Proposal for the 03 series of amendments to UN Regulation No. 118 (Burning behaviour)

"Figure 1
Specimen holder (Dimensions in millimetres)

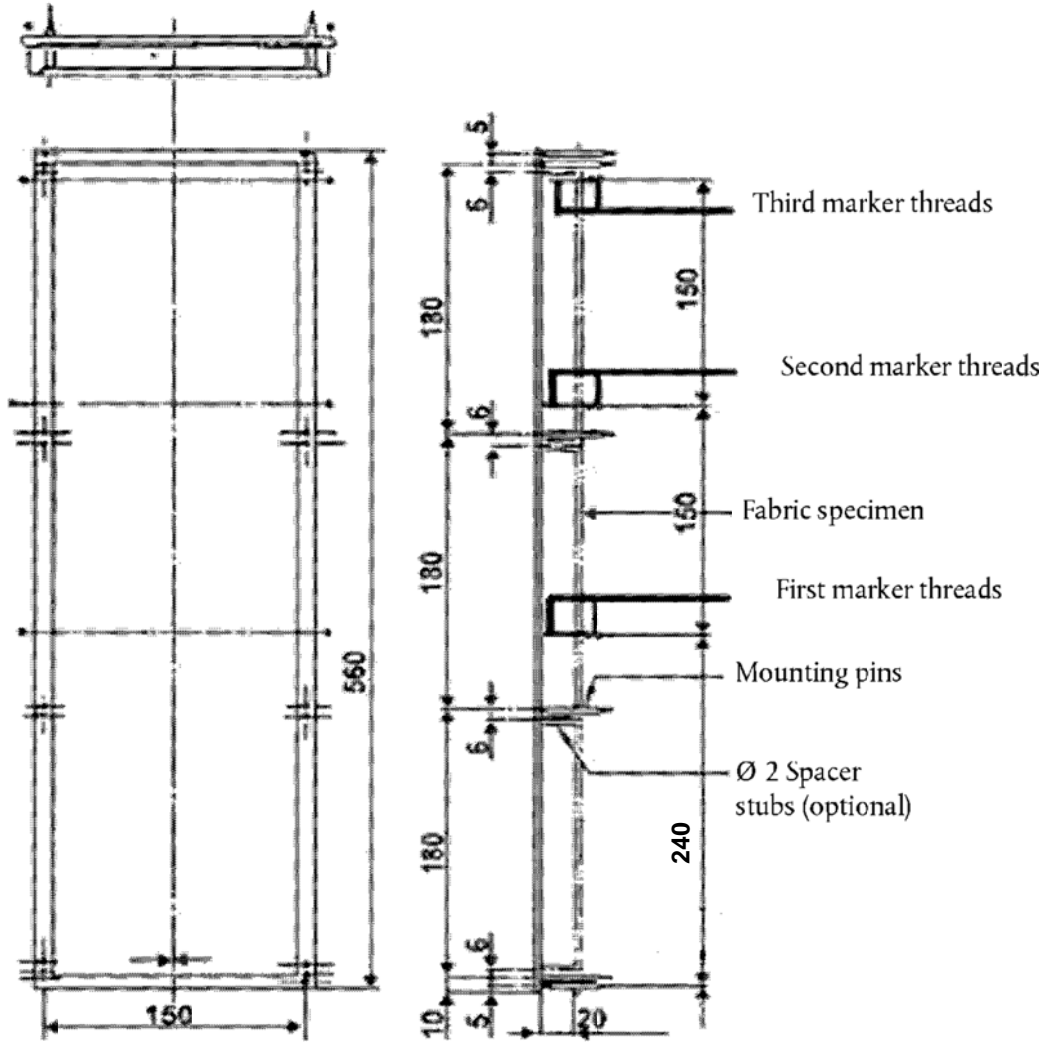
Figure 1, amend to read (removing "Burner" at the bottom and replacing "220" by "240"):

The specimen holder shown in Figure 1 may be modified in width to allow the fixation of the sample.
